Seabrook Station

Response to Request for Additional Information for License Amendment Request 14-04  
Revised Reactor Coolant System Pressure - Temperature Limits Applicable for 55 Effective  
Full Power Years

**ENCLOSURE to SBK-L-15132**

FIGURE 3.4-2  
REACTOR COOLANT SYSTEM HEATUP LIMITATIONS – APPLICABLE UP TO 55 EFPY

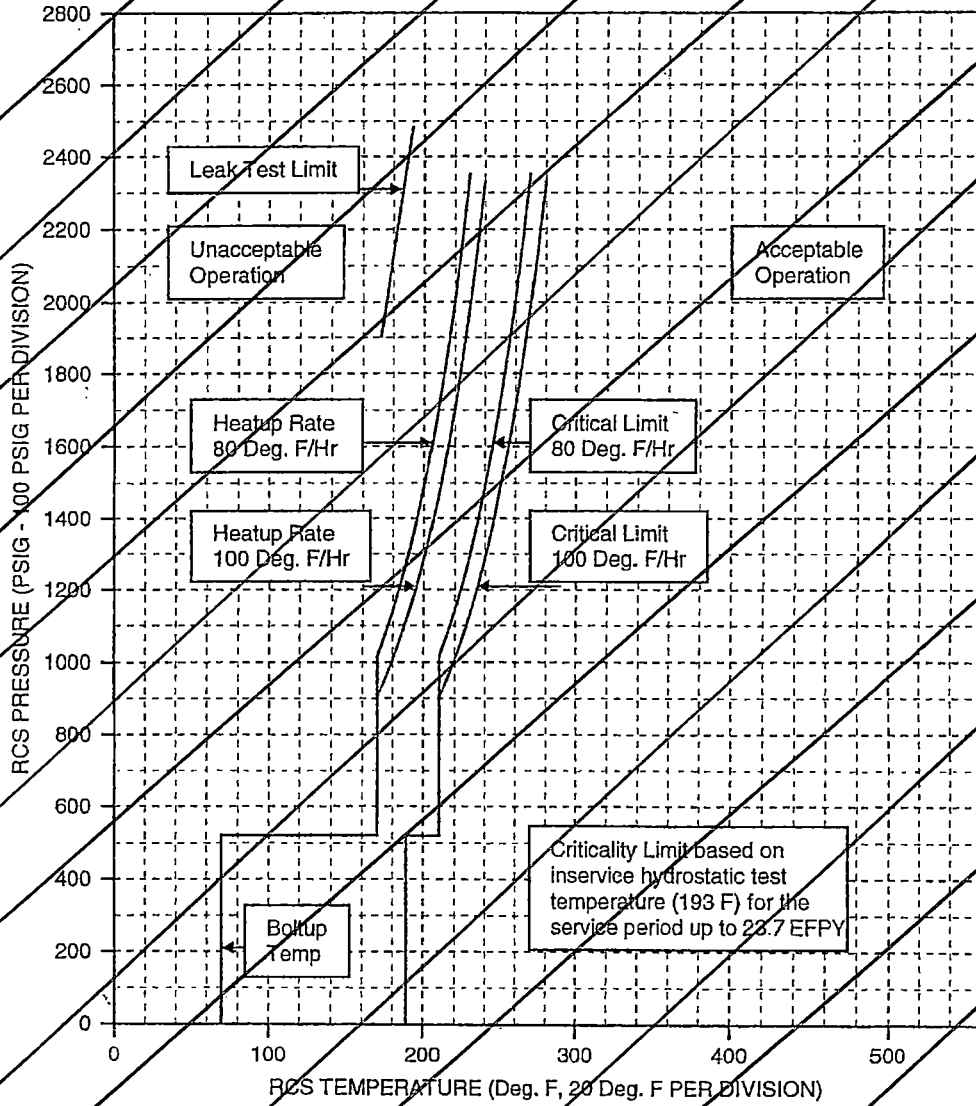
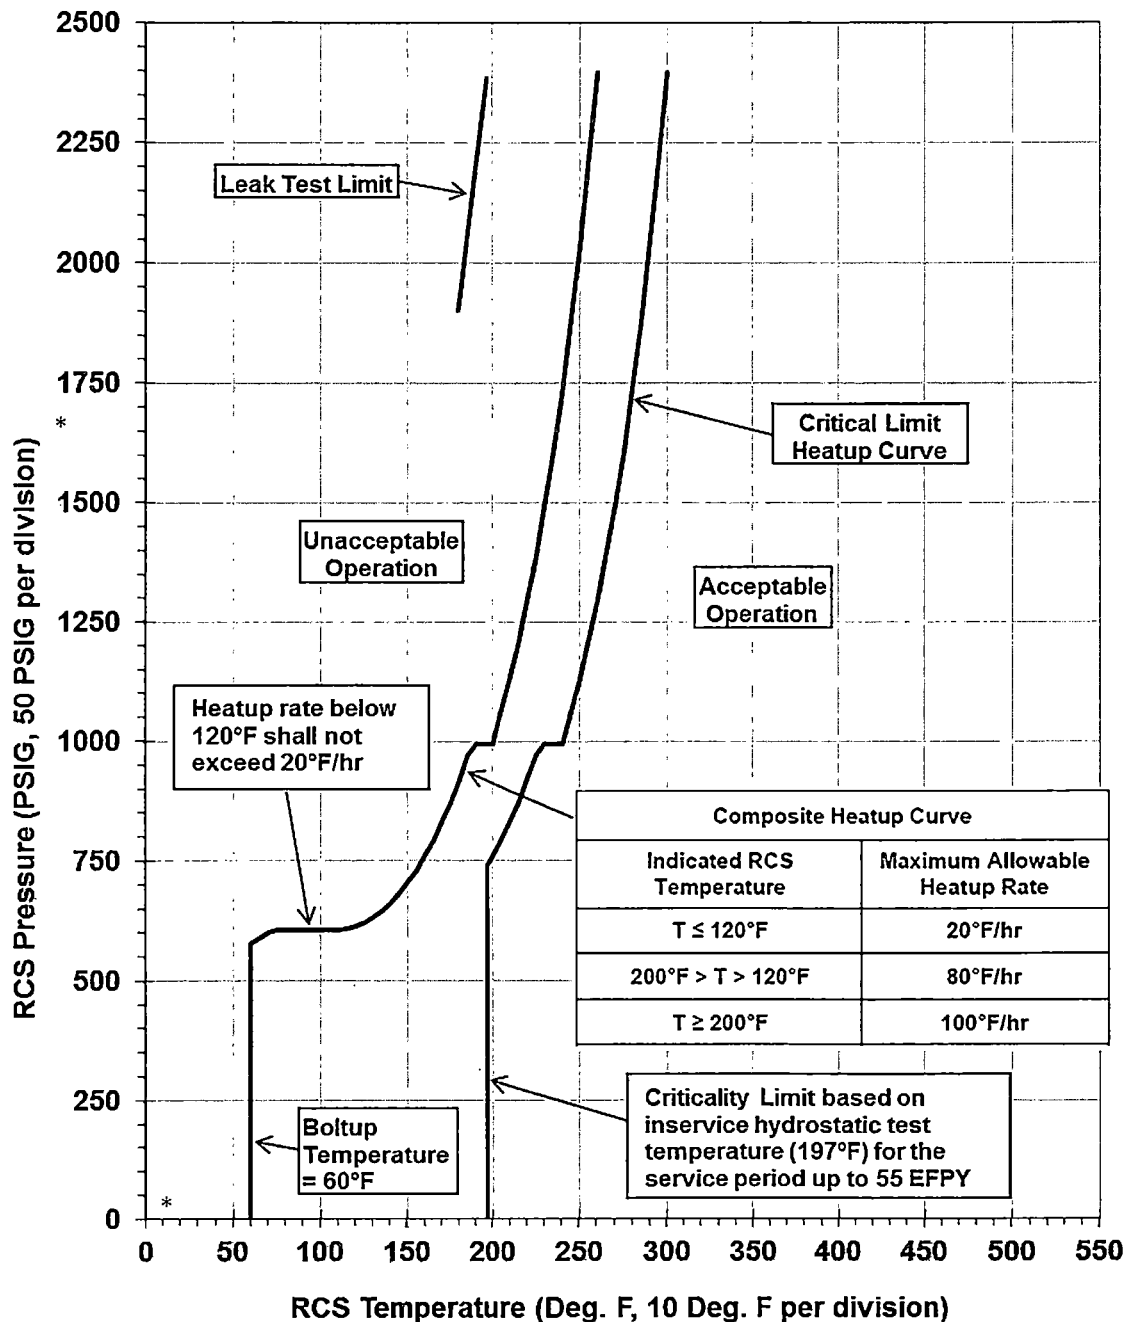
*NRC RAI 2.2.1: The current TS P-T limit curves for 23.7 EFPY have margins to account for pressure and temperature instrument errors; the proposed 55 EFPY TS P-T limits do not have these margins.*

*Please address how instrumentation errors will be accounted for to ensure that the RCS is operated in accordance with the proposed TS P-T limits for 55 EFPY.*

For the heat up limitation curve, proposed TS Figure 3.4-2, a heat up rate restriction of 20°F/hr was added at temperatures at or below 120°F, corresponding to the transient defined in WCAP-17444 and the previous response to RAI 2.1.4. At temperatures greater than 120°F to less than 200°F the heat up rate of 80°F/hr maximum is specified and at greater than or equal to 200°F the maximum rate is 100°F/hr. Instrument uncertainties of 20°F and 100 psi were added to the data points in WCAP-17441-NP Table 6-3. An additional pressure uncertainty of 15 psi was added to the heat up curve starting at 200°F prior to the cold overpressure mitigation system being disabled. Considering the 20°F/hr rate restriction, pressure and temperature data from 60°F to 80°F (40°F to 60°F without the instrument uncertainty of 20°F) were determined using the more limiting pressure rate change between the existing 80°F/hr heat up data and the steady state data. Linear extrapolation of the 60°F to 65°F allowable pressure change of 13 psi per 5°F was applied to the heat up curve pressure limits from 60°F to 80°F. These heat up rate limitations and instrument uncertainties additions result in all pressure limitations at or below 225°F, in the COMS enable temperature region, being above and protected by the COMS system set point curve in TS Figure 3.4-4.

The proposed heat up limitation curve, TS Figure 3.4-2, and the proposed cool down limitation curve, TS Figure 3.4-3 applicable for 55 EFPY have been revised to include margins to account for pressure and temperature instrument uncertainty as described above and are provided in the attachment. The revised data points for the revised heat up and cool down curves are provided in Tables 1 and 2 respectively.
